OBJECTION TO PROJECT

MALLEE WIND FARM SITED FOR MAXIMUM ENVIRONMENTAL IMPACT

FIGURE ES.4 Project Constraints

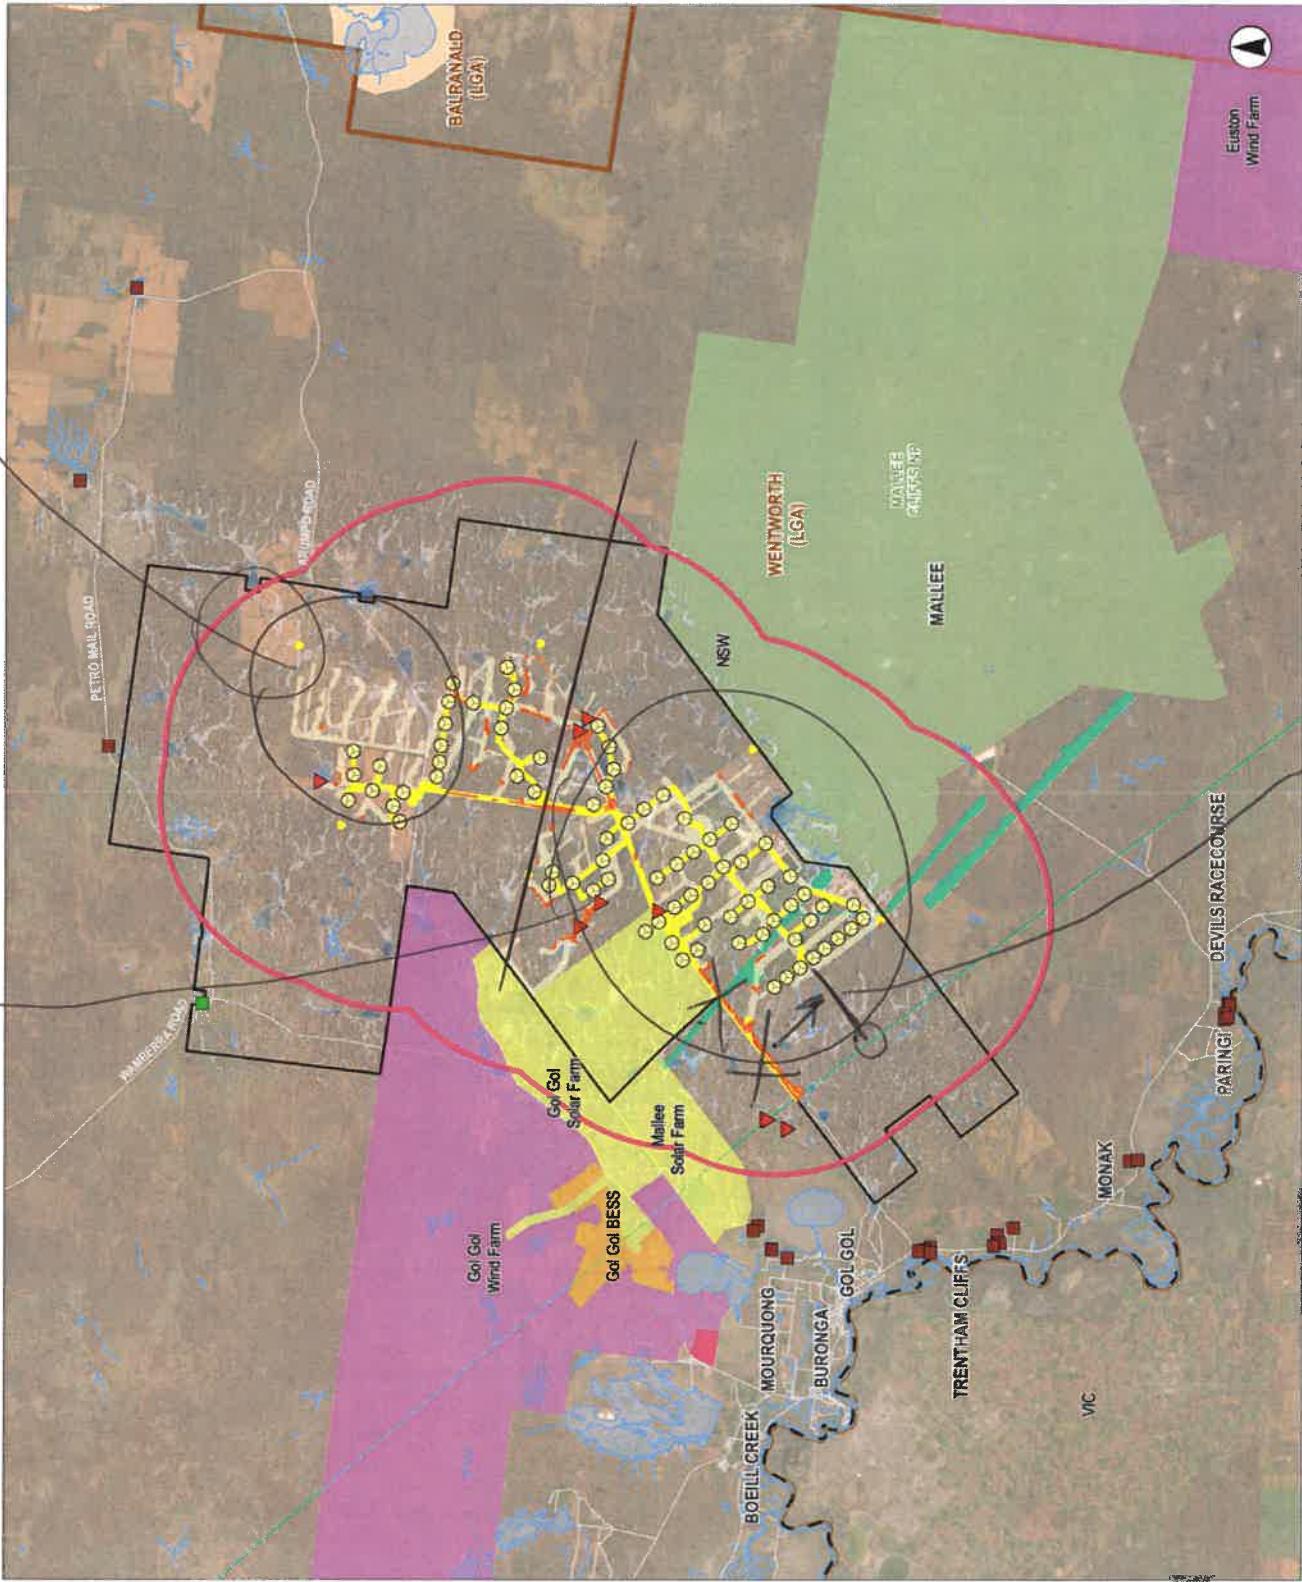
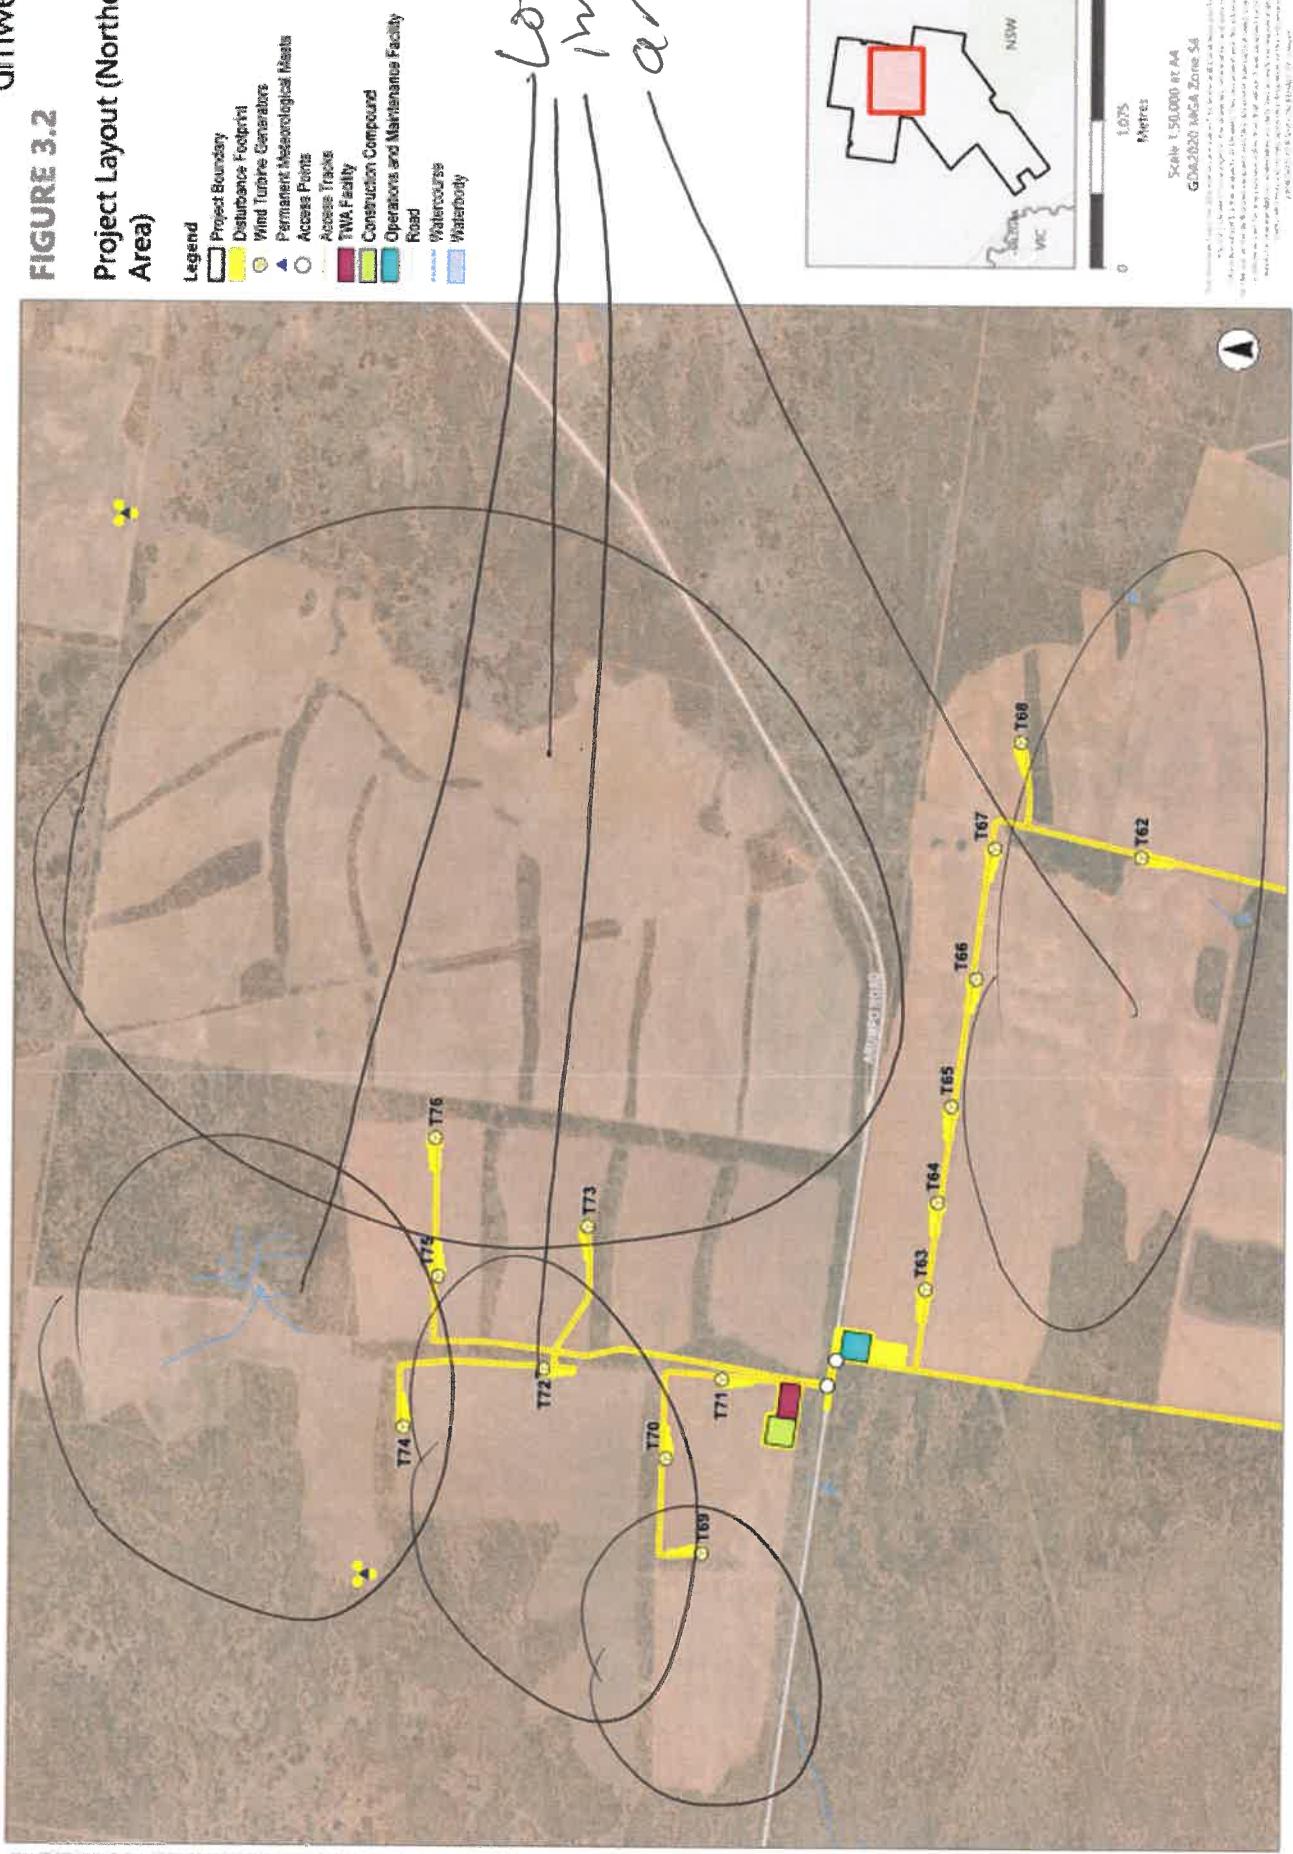
- moving all the Southern wind turbines and the lower half of the Central wind turbines to the northern Project Area
- relocating the transmission line and switching station 2km east to provide a buffer around it

high impact
area - delete. / lower impact
area.

The attached maps show how, within the same Project Area, wind turbines could be relocated to have lower impact on Buronga Gol Gol and the Mallee Cliffs National Park.

FIGURE 3.2
Project Layout (Northern Area)

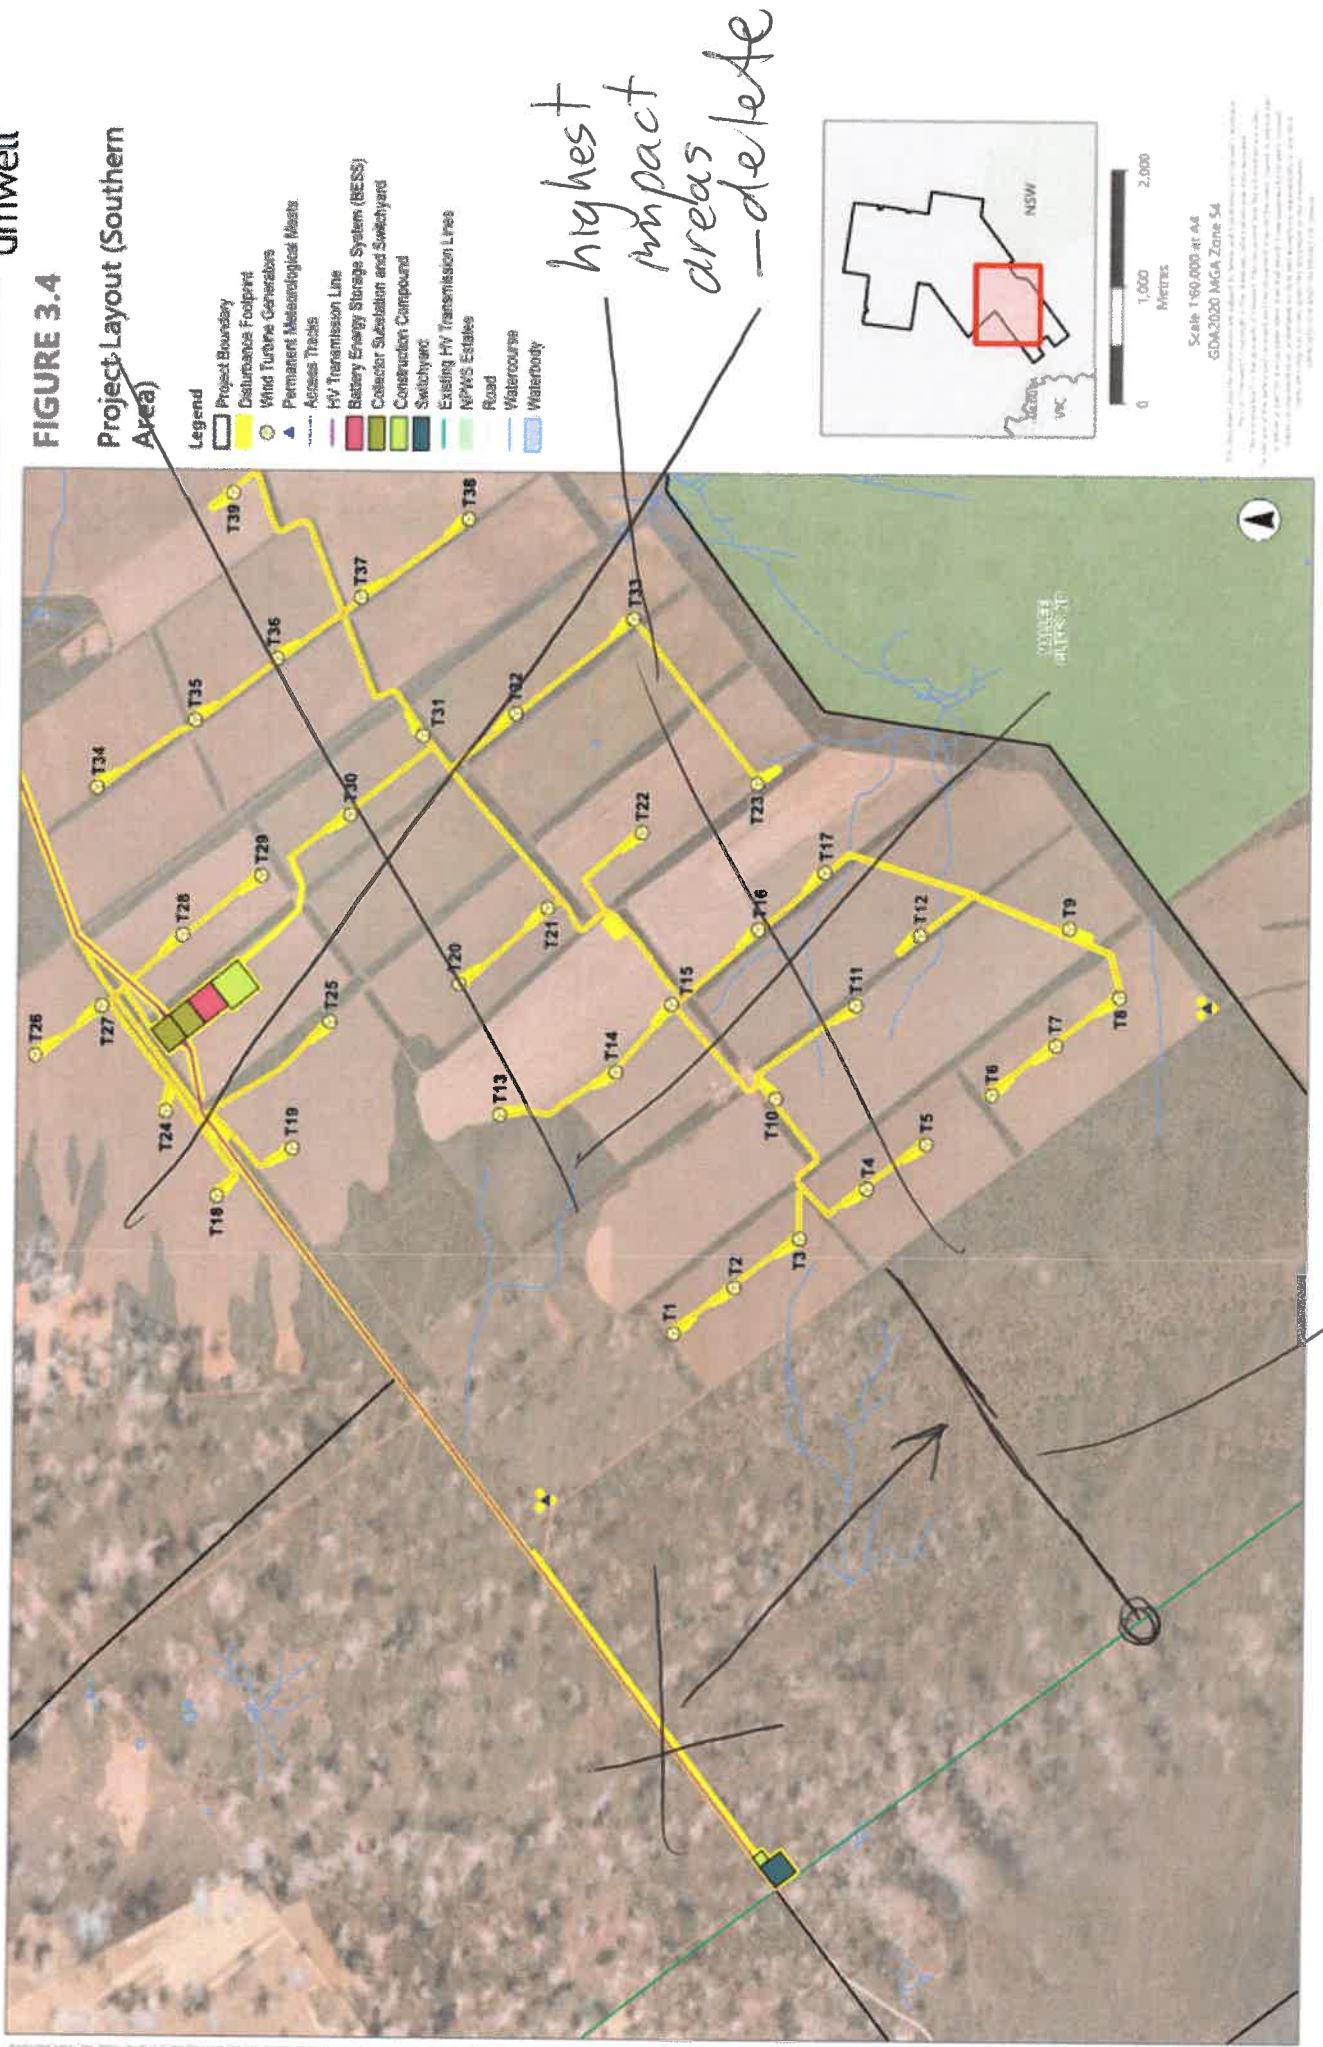
lower impact areas.
